ISLANDS PLANNING COMMISSION STAFF REPORT

Meeting Date: July 21, 2020

Application Type	Village Preservation
Case Number	VP4300
Applicant	James A. Bishop, agent, for Sandy Vacation, LLC, owner
Property Address	513 Beachview Drive, 315 15 th Street, 108, 118, 124, 130, and 140 Pier Village Market, 300, 308, and 310 Mallery Street, and 508 Oglethorpe Avenue, St. Simons Island
Parcel ID	04-04653, 04-04652, 04-10230, 04-11659, 04-07017
Area of Property	0.55 acre (combined lots)
Existing Zoning	Village Mixed Use (VMU) and Island Preservation Design Review District (IP) and the applicant is proposing to rezone it to Planned Development District (PD) (case number ZM4299) and Island Preservation Design Review District (IP)
Existing Land Use	Commercial (retail and office) and Residential
Proposed Zoning	Planned Development District (PD) and Island Preservation District (IP)
Proposed Land Use	Art Museum

NARRATIVE: ST. SIMONS ART MUSEUM

1 CONCEPTUAL WEST ELEVATION - MALLERY STREET
SCALE: 1/8" = 1'-0"

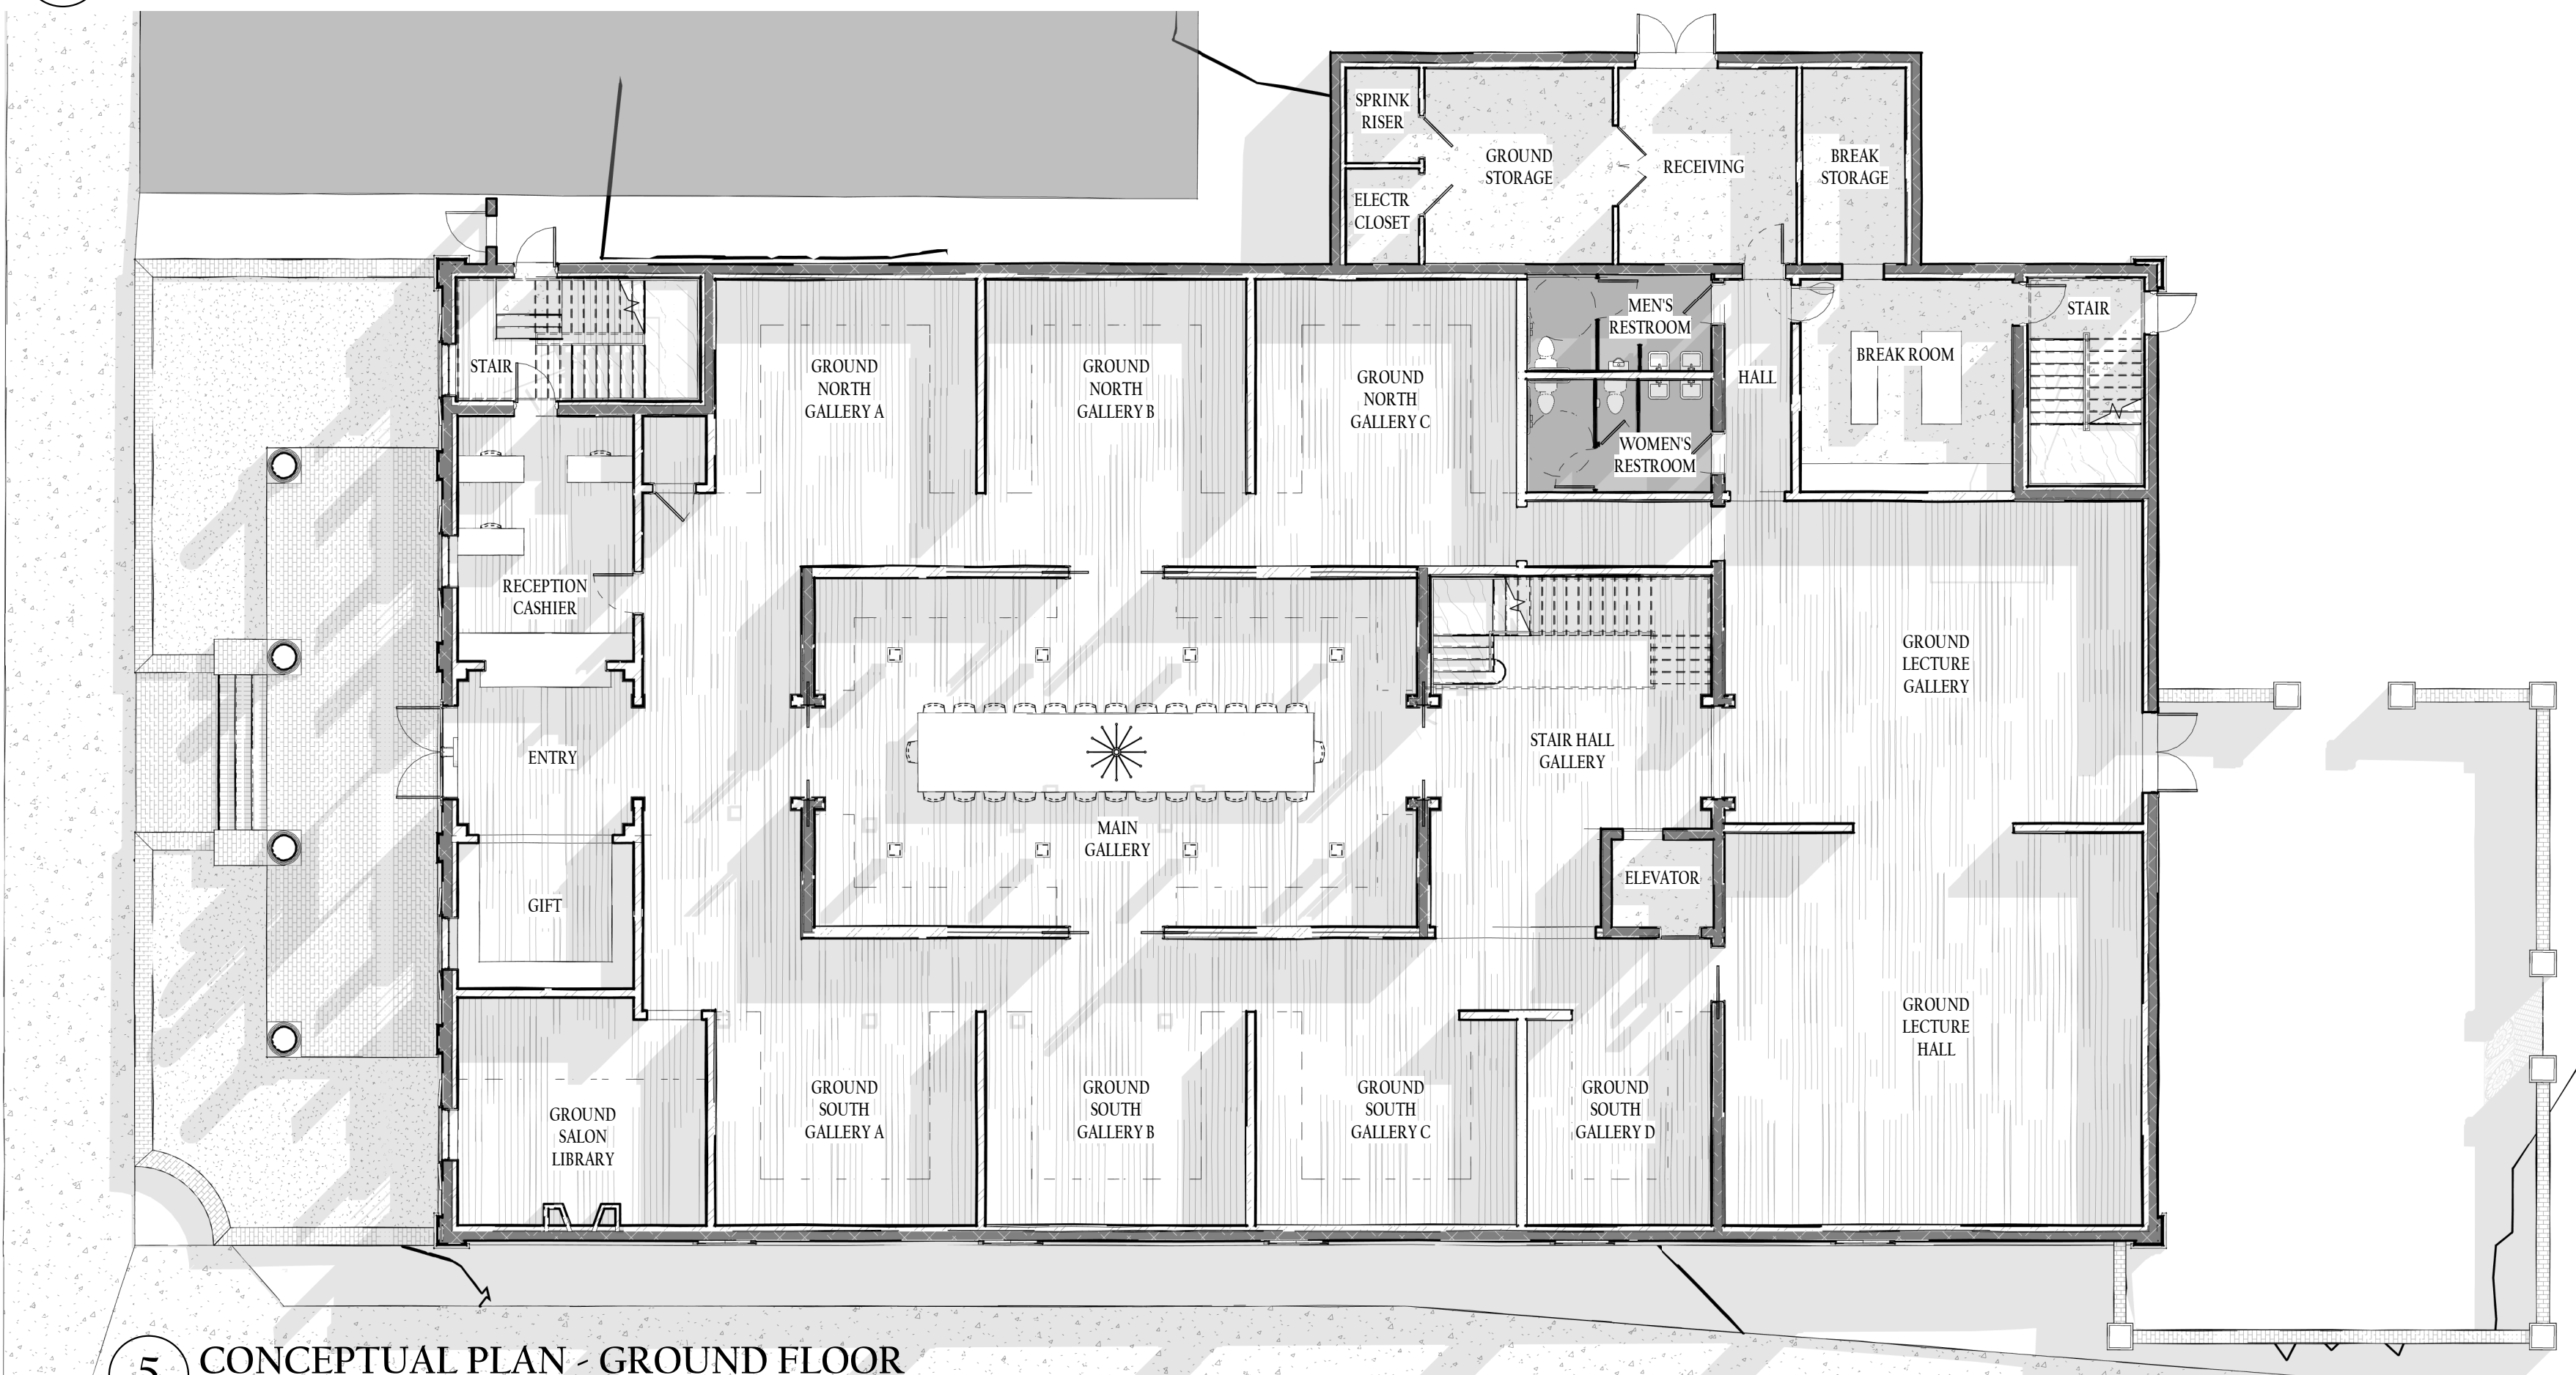
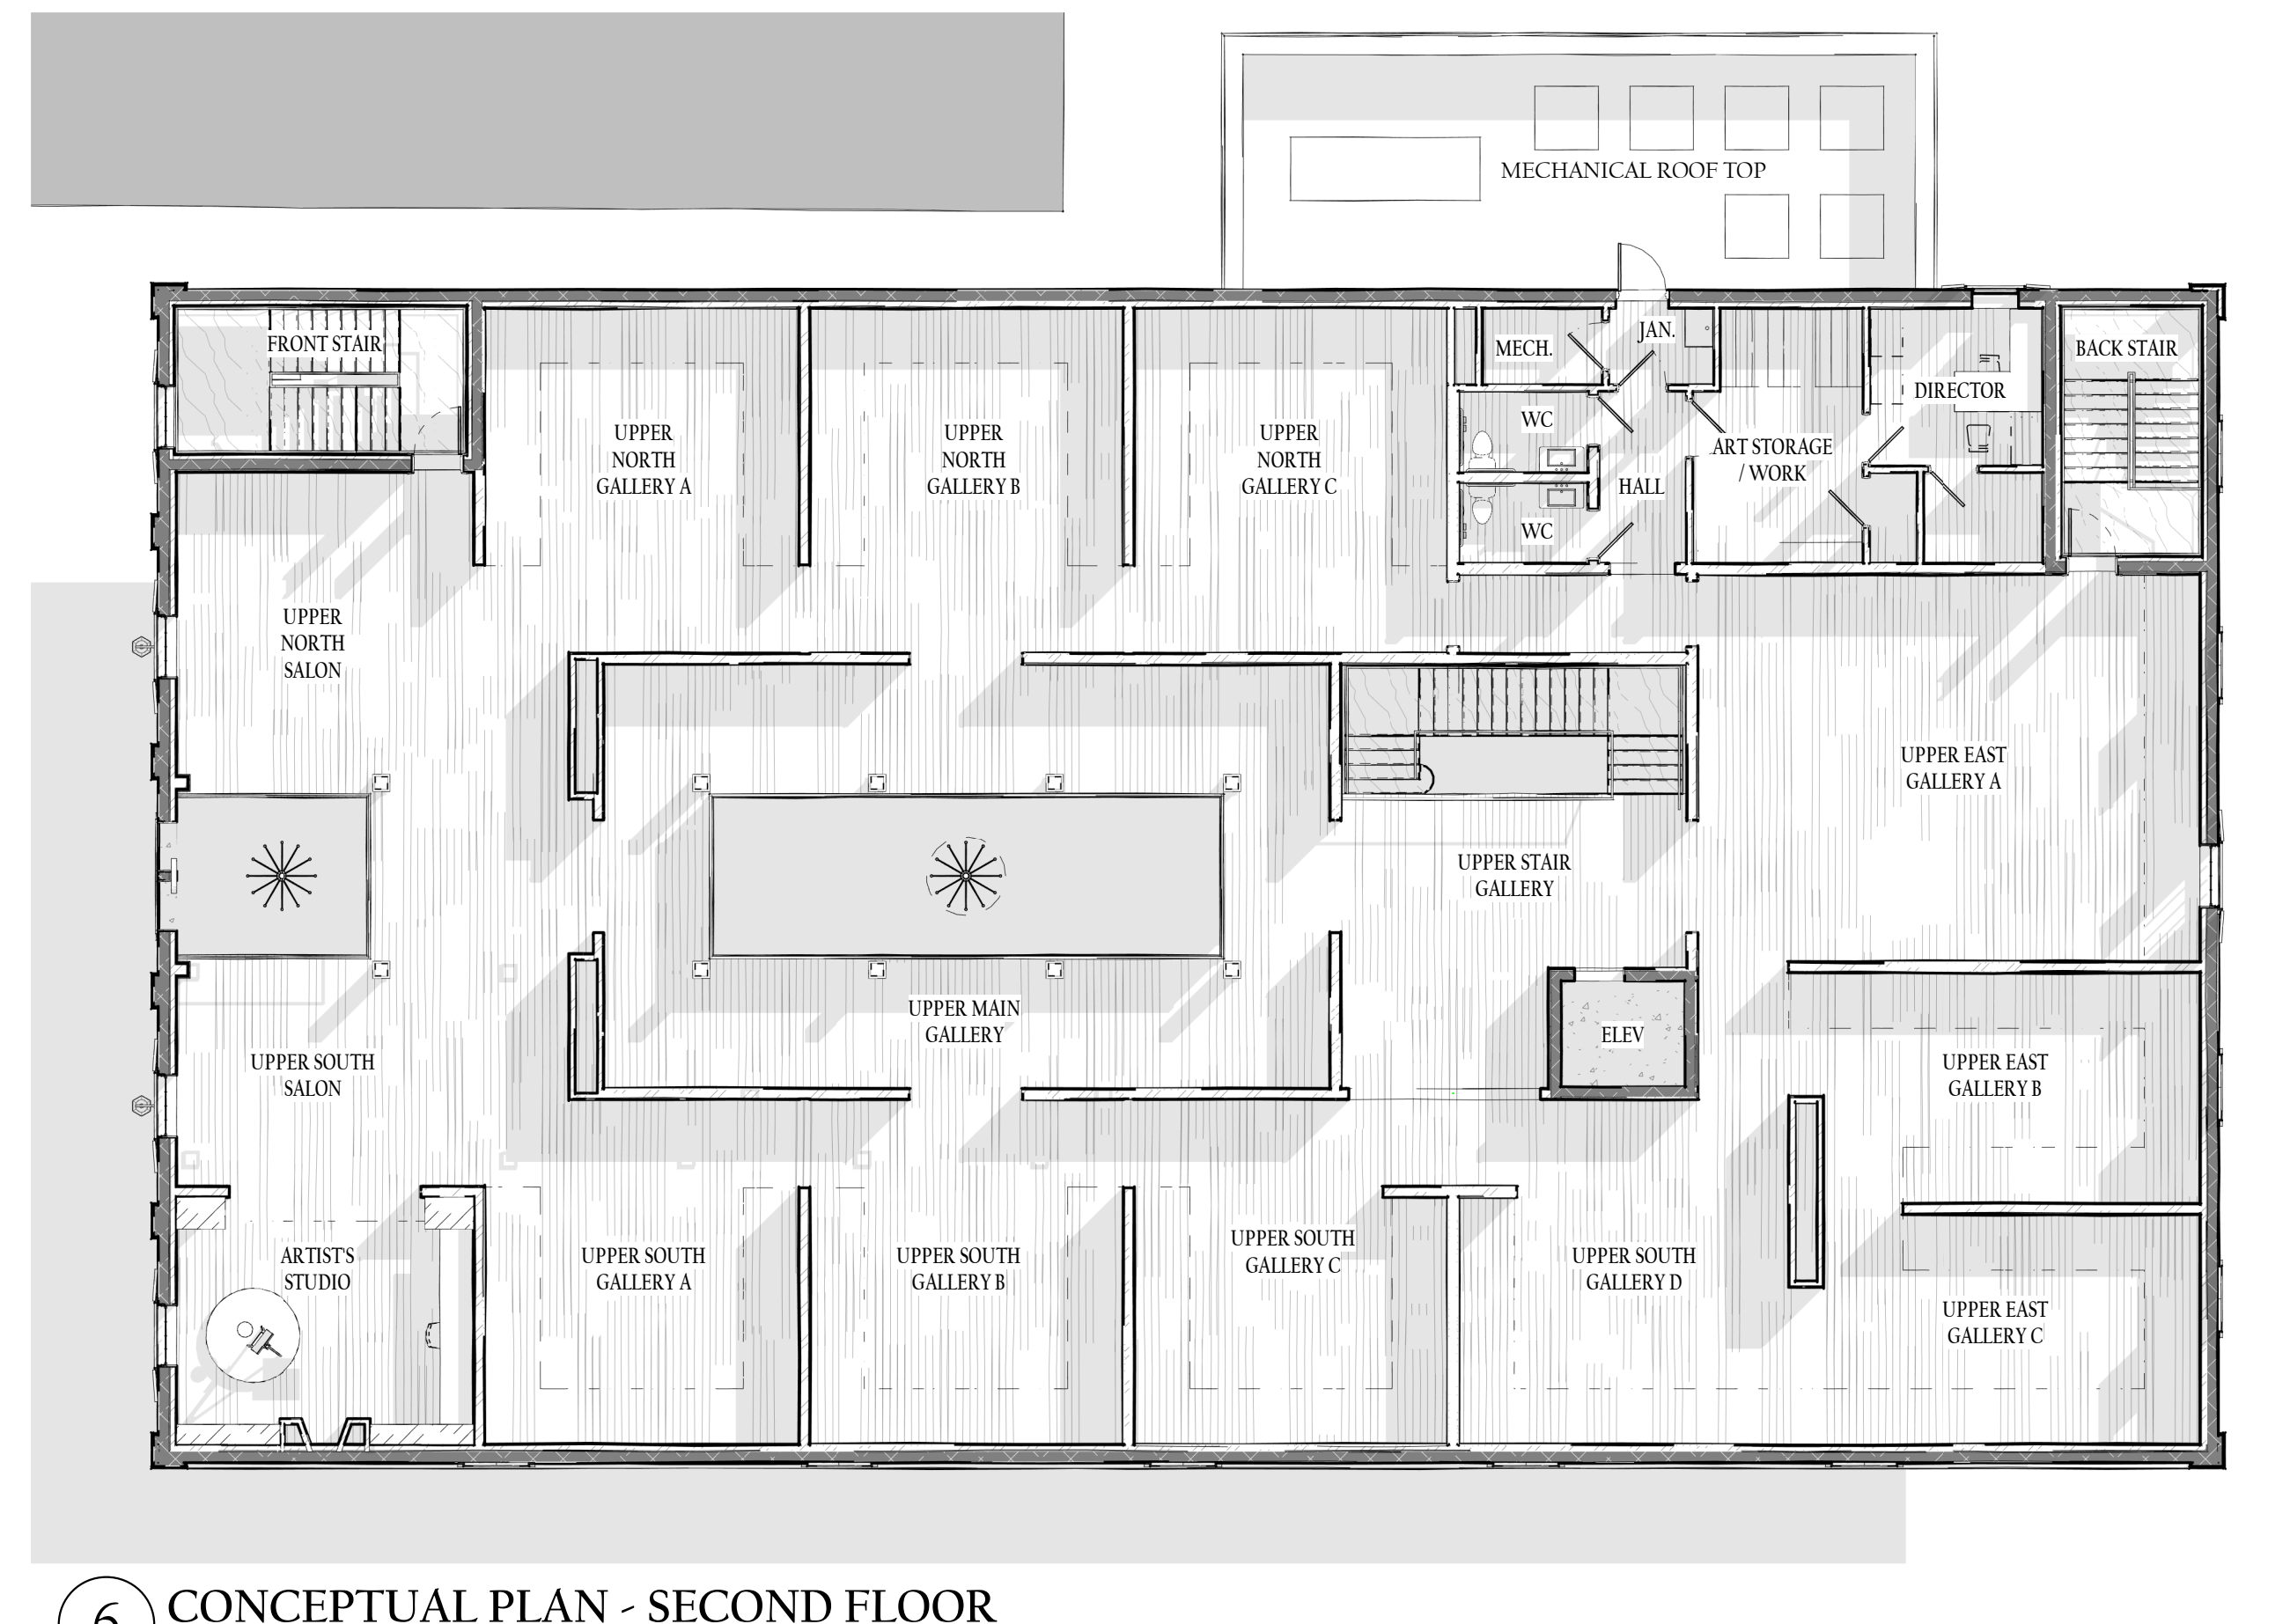
- **The proposed privately-funded art museum is primarily Greek Revival style with influences of the St. Simons Lighthouse and Keepers Cottage architect, Charles B. Cluskey. The primary entrance will be from Mallery Street and the length of the side elevation will be along Beachview and Oglethorpe. An open space is proposed along 15th Street between Beachview and Oglethorpe.**

- **Exterior materials include a stucco siding in “Honey Bees” yellow; “White Dove” for the front columns and trim, shutters in “Hunter Green,” brick base, and the roof will either be standing seam metal or asphalt shingles**
